Re: American Airlines
JFK Concourse B/Terminal 8
Admiral Club – 4th Floor Main Terminal
App. No. Y-8171
Maintenance Approval M-2115

RE: JFK Maintenance Approval M-2115
Terminal 8 - American Airlines
Concourse B - Admirals Club & Flagship Lounge - Punch List Repairs

REMEDIATION FOR PUNCH LIST OF
ADMIRALS CLUB / FLAGSHIP LOUNGE
CONCOURSE B, 4TH FLOOR TERMINAL 8
JOHN F. KENNEDY INTERNATIONAL AIRPORT
JAMAICA, NEW YORK 11430

RE: JFK Alteration Application Y-8171
Terminal 8 - American Airlines
Concourse B - Temporary Admirals Club & Flagship Lounge - Egress Analysis

SHEET NO.
A-010

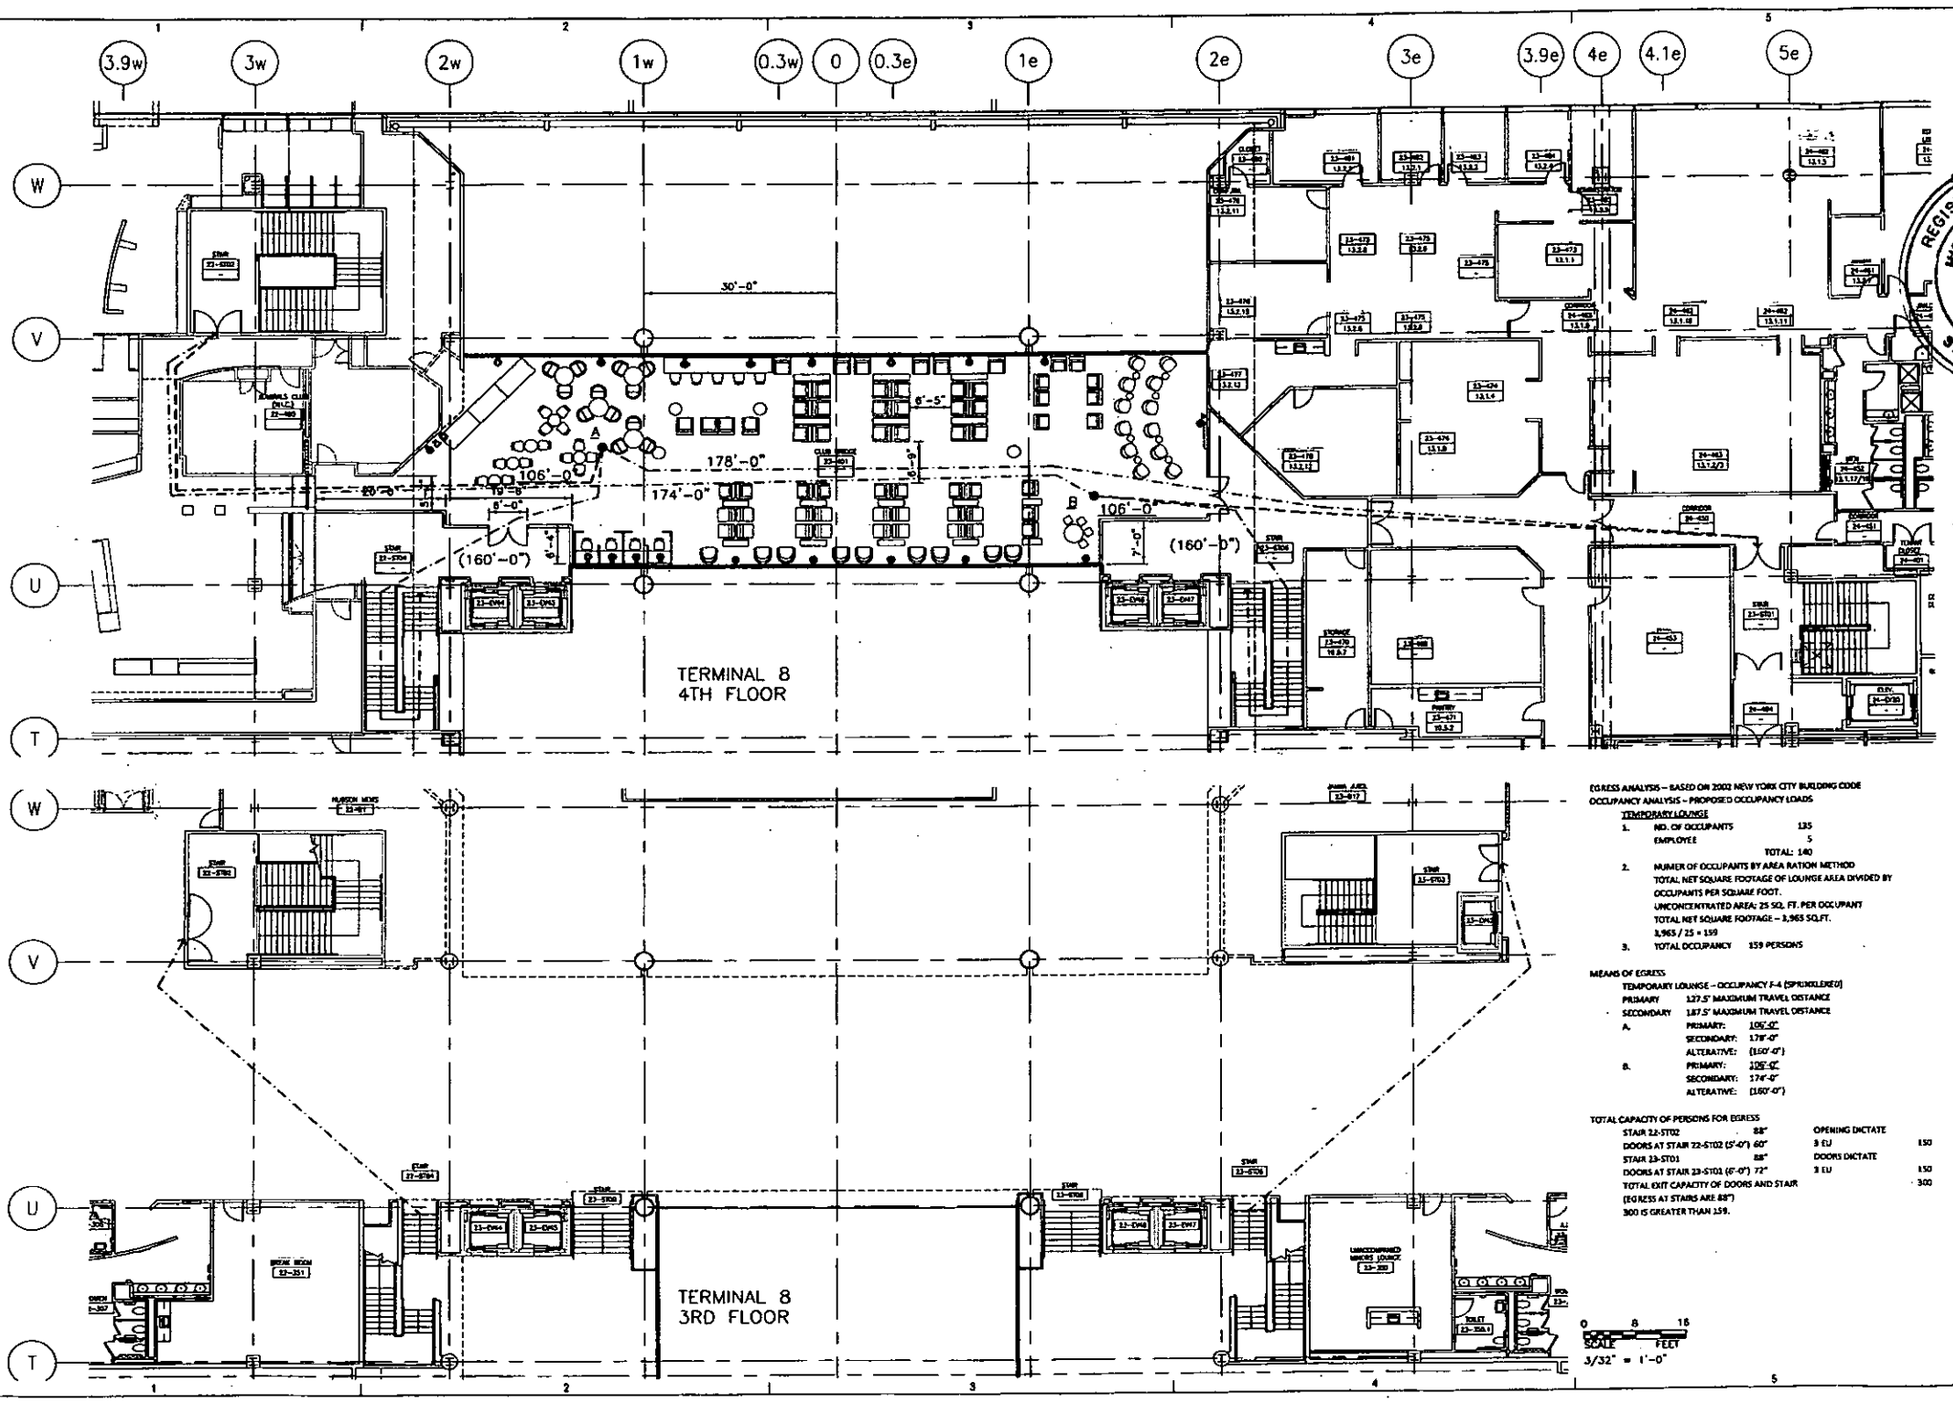
Maurice:
I spoke to Mario Palmieri as you suggested. After speaking with him, I agree we should use the 1968 version of the NYC Building Code with the 2002 supplements.
Attached is an updated drawing using the 2002 version of the NYC Building Code. We are in compliance with egress requirements and travel distances for the temporary club.

Occupants
2008 Code: 15 occupants per sq. ft. = total of 241 occupants.
2002 Code: 25 occupants per sq. ft. (used in TAA Y-7100.06 and the Admirals Club in Concourse C and Concourse B) = total of 159 occupant.

Travel Distances
2008 Code: Primary = 150 feet, Secondary = 250 feet
2002 Code: Primary = 127.5 feet, Secondary = 187.5 feet

We have egress units within the travel distances for 300 persons, based on the 2002 NYC Building Code.

In conclusion, whether we follow the 2008 or 1968 version with supplements of the NYC Building Code, we are in compliance with the egress and travel distances.

Port Authority staff has reviewed the drawings and other materials submitted under cover of letter from Transsystems Corporation dated February 10, 2009. Approval has been granted and there are no comments. I have attached a signed copy of the approved Alteration Application form.
